SUBJECT: Forwards response to 830726 request for addl info re  
 proposed expansion of spent fuel pool. Cask drop protection  
 sys within pool consists of dashpot supported vertically by  
 pool floor.

Re: Nine Mile Point Unit 1  
Docket No. 50-220  
.....DPR-63.....

NRC REQUEST FOR ADDITIONAL INFORMATION  
NINE MILE POINT SPENT FUEL POOL  
EXPANSION - STRUCTURAL ASPECTS

BY D. P. ... DATE 7/27/83 SUBJECT NMPL-IT SHEET NO. 2 OF      
CHKD. BY     DATE     QUEST 14 PROJ. NO. 8202

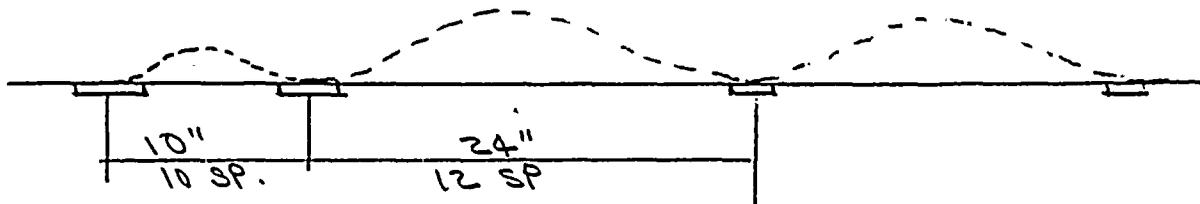
NRC request to provide additional analysis on maintaining liner integrity under global loading (buckling) and rack local loading conditions.

IN THE  $E-W$  DIRECTION THE MIN LINEAR SPAN IS  $10\frac{1}{2}$ " & MAX IS  $24\frac{9}{16}$ " WITH AN AVERAGE OR  $23\frac{13}{16}$ ". SINCE THE PLATE IS BACKED UP BY CONCRETE, IT WILL BUCKLE IN THE FOLLOWING CONFIGURATION:

$$\sigma_{CR} = \frac{\pi^2 (28 \times 10^6)}{[0.5(10)/0.072]^2} = 57,300 \text{ PSI}$$

SINCE  $F_y = 25,000 \text{ PSI}$  THE LINEAR WILL YIELD PRIOR TO BUCKLING.

$$\text{FOR } 24" \text{ SPAN } \sigma_{CR} = \frac{\pi^2 (28 \times 10^6)}{[0.5(24)/0.072]^2} = 9,950 \text{ PSI}$$

$\therefore$  THE 24" SPANS WILL BUCKLE PRIOR REACHING THE FULL COMPRESSIVE STRESS OF 32,700 PSI. HOWEVER THE DISTANCE BETWEEN CHANNELS MUST STILL BE REDUCED BY  $\epsilon L = .0008(24) = -.0194 \text{ IN.}$
